Ground Floor Strategy

Consented Scheme

Revised Scheme

Ground Floor Strategy

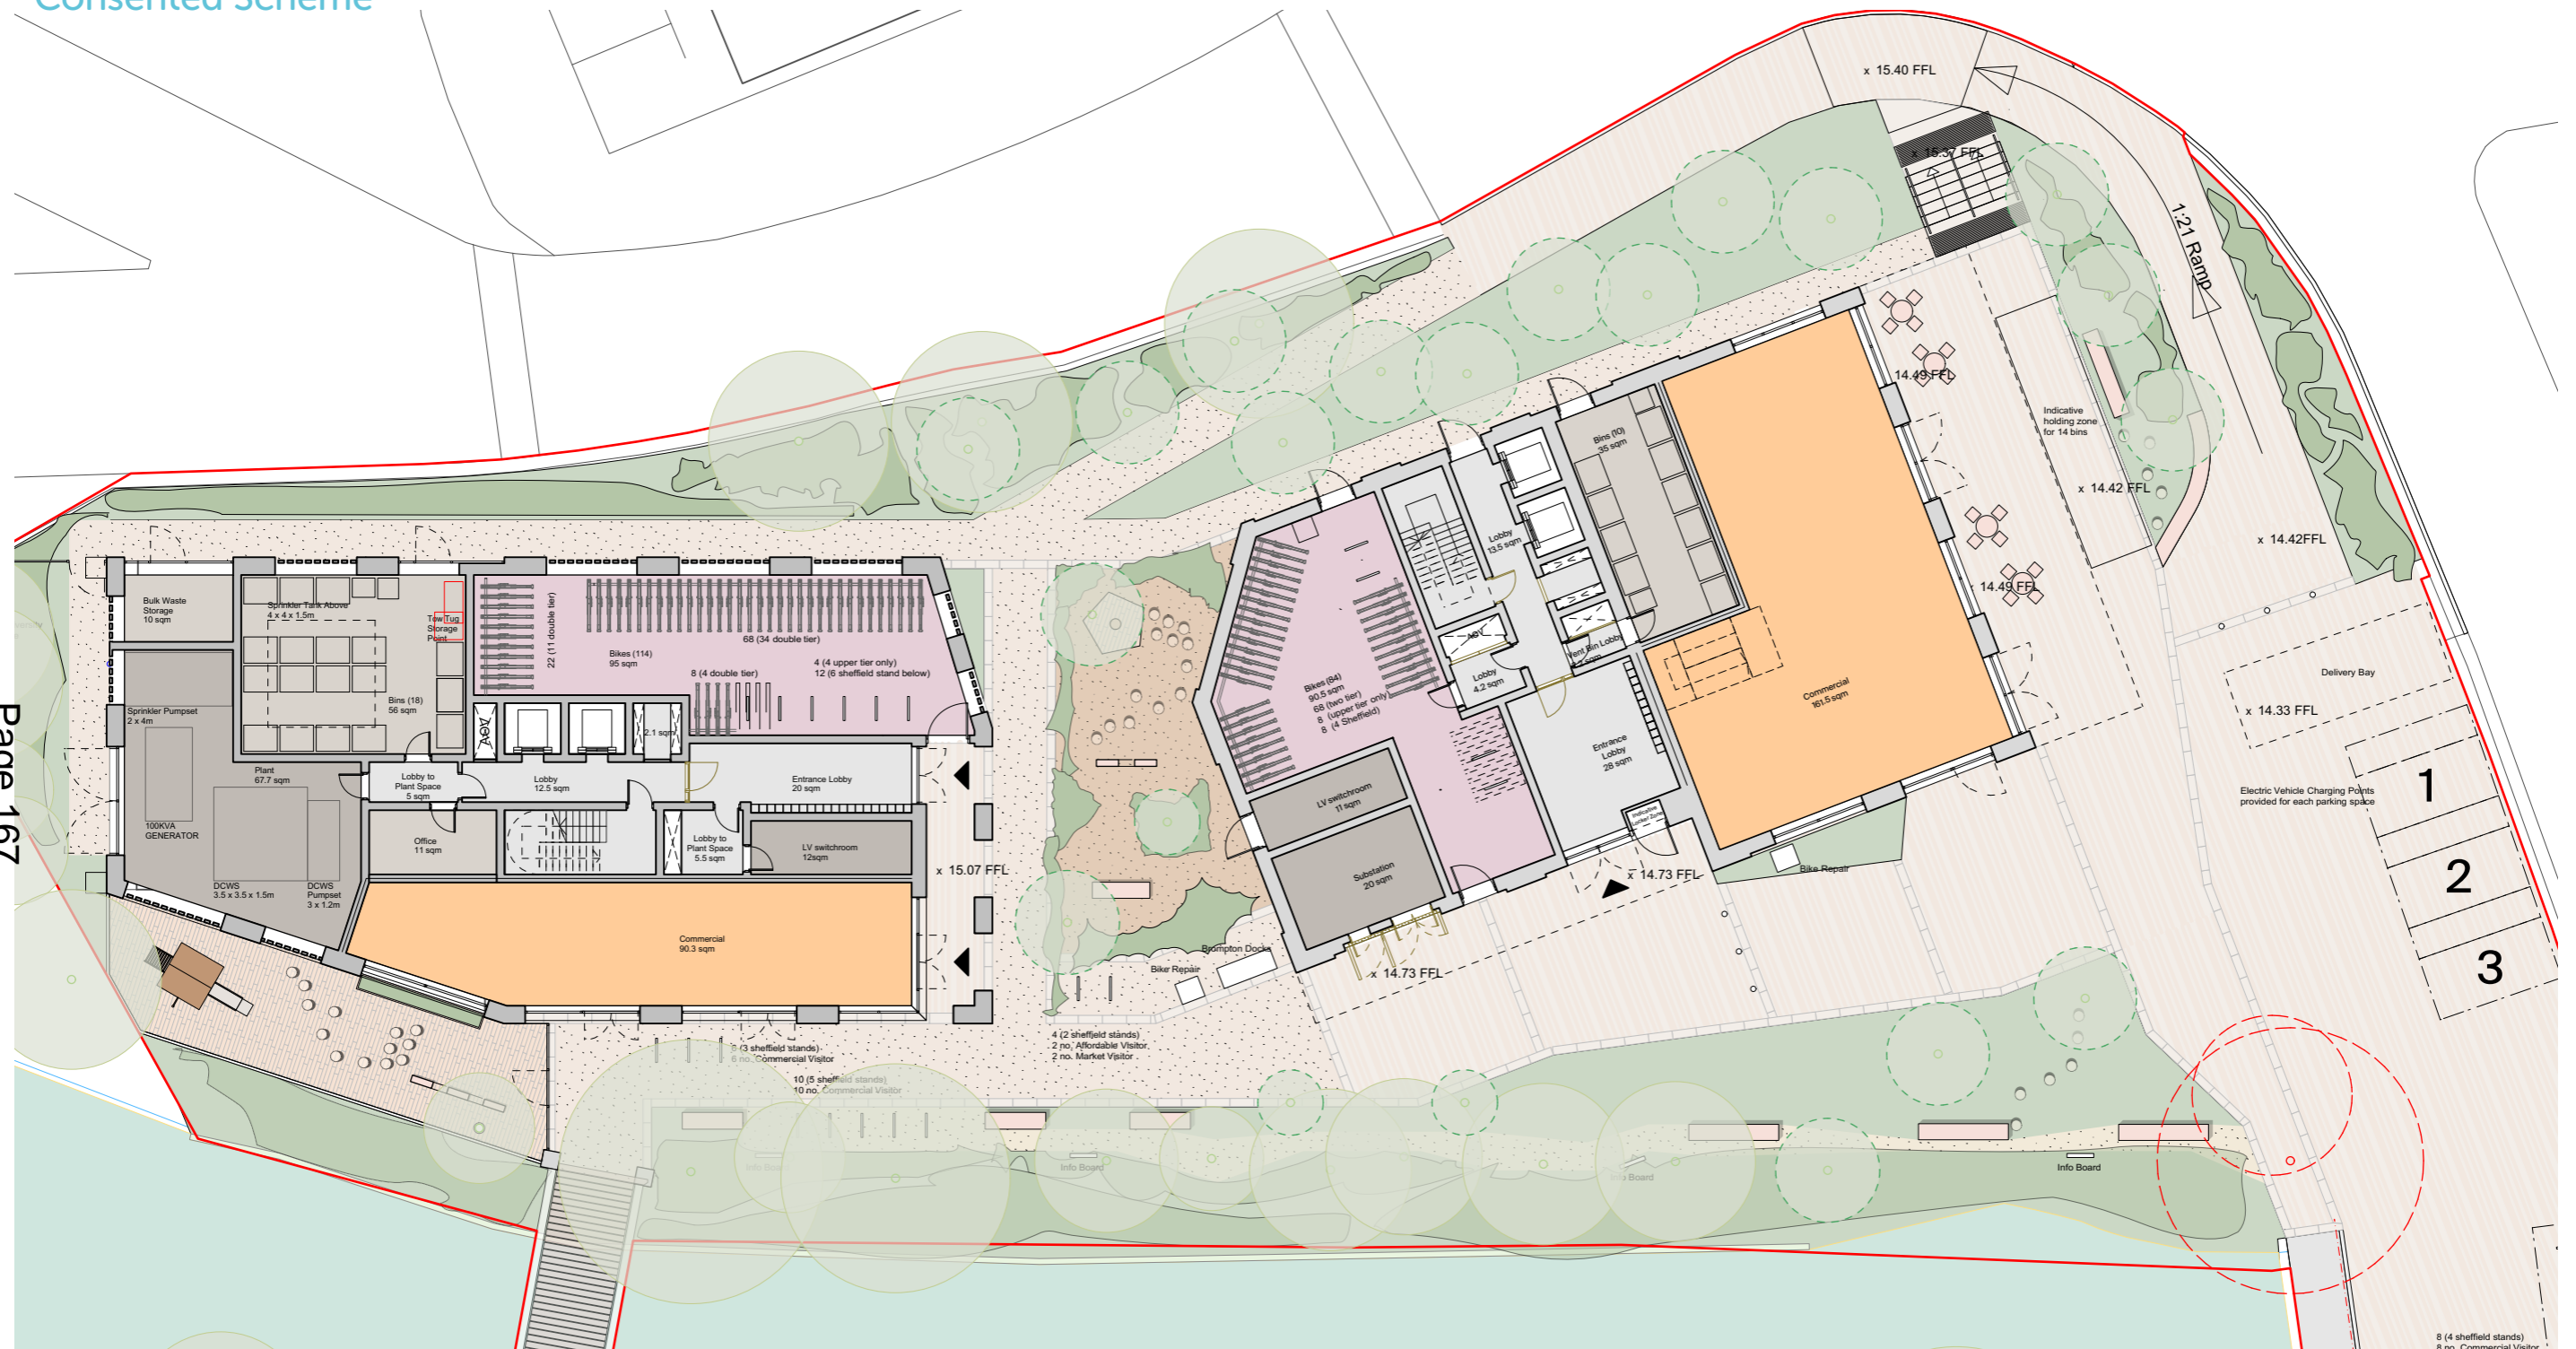
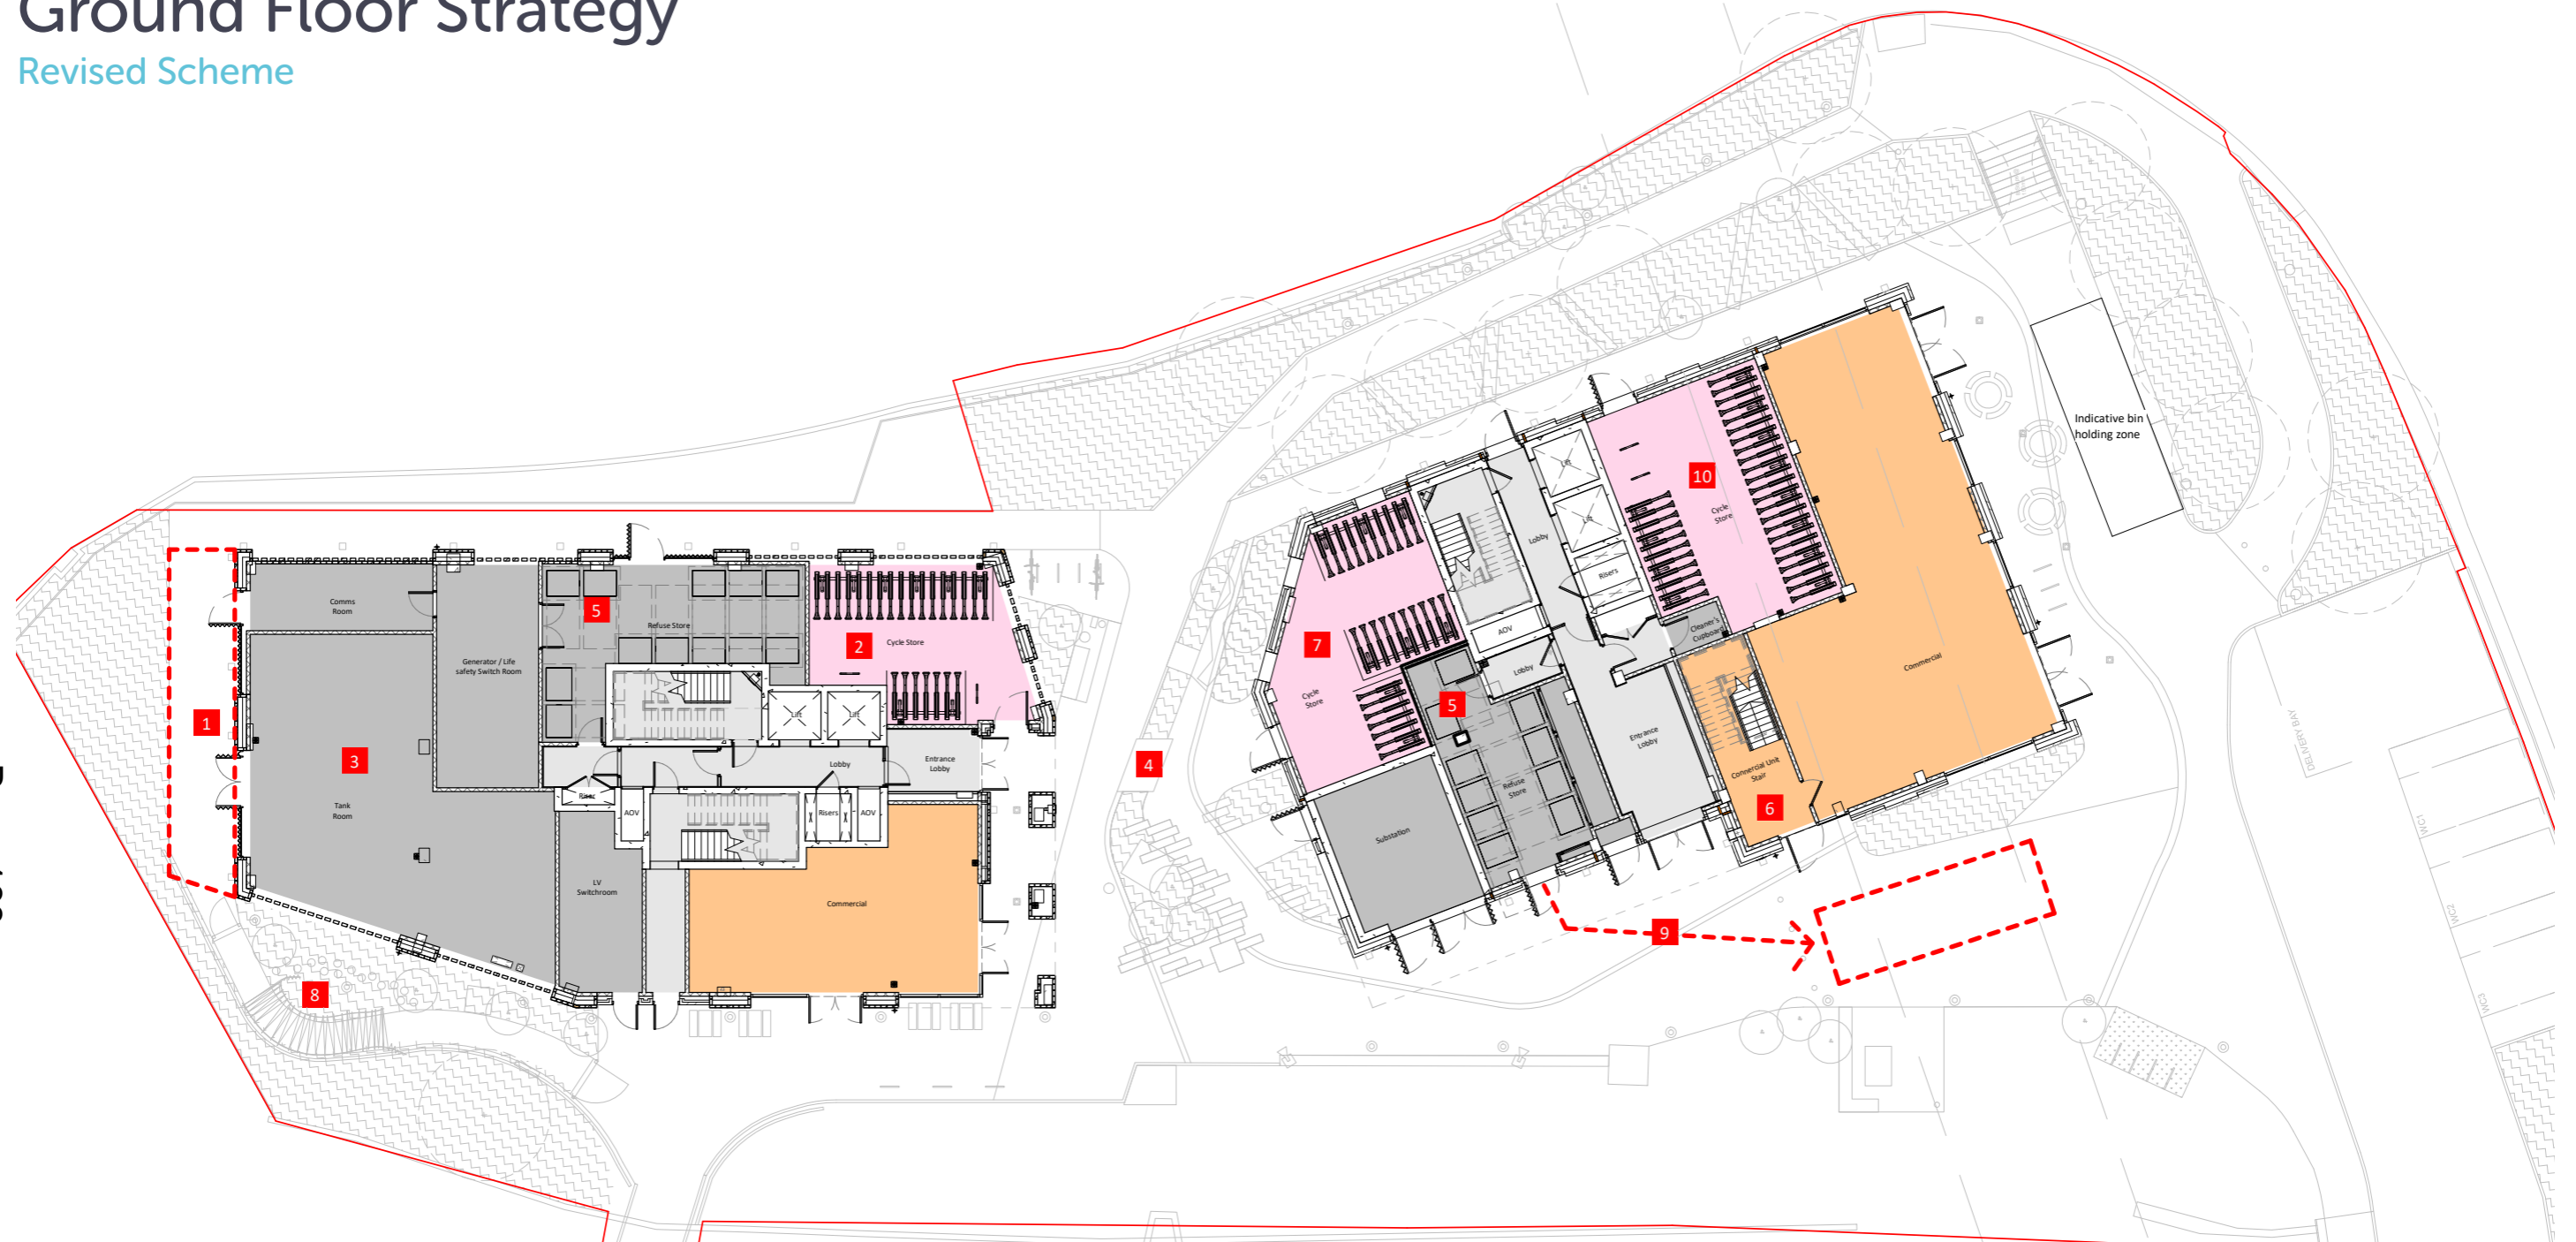
| 1 Reduction in North Block building footprint | 6 Protected stairs added to commercial unit | Commercial |
| 2 Cycle store reduced to incorporate refuse store | 7 Cycle Store added to include remaining cycles from other block | Cycle store |
| 3 Internal layout rearranged, larger plant room | 8 Landscaping layout & play space updated. Refer to Farrer Huxley Comparator Document for further details. (DL0221-FH-XX-XX-RP-L-0003) | Refuse Store |
| 4 Introduction of pathway between blocks to provide access to the Refuse Store | 9 10m pull distance from refuse store to refuse collection point | Plant Room |
| 5 Refuse Store relocated/reduced to serve per block | 10 Cycle store serving the associated block | Refuse Collection point. |
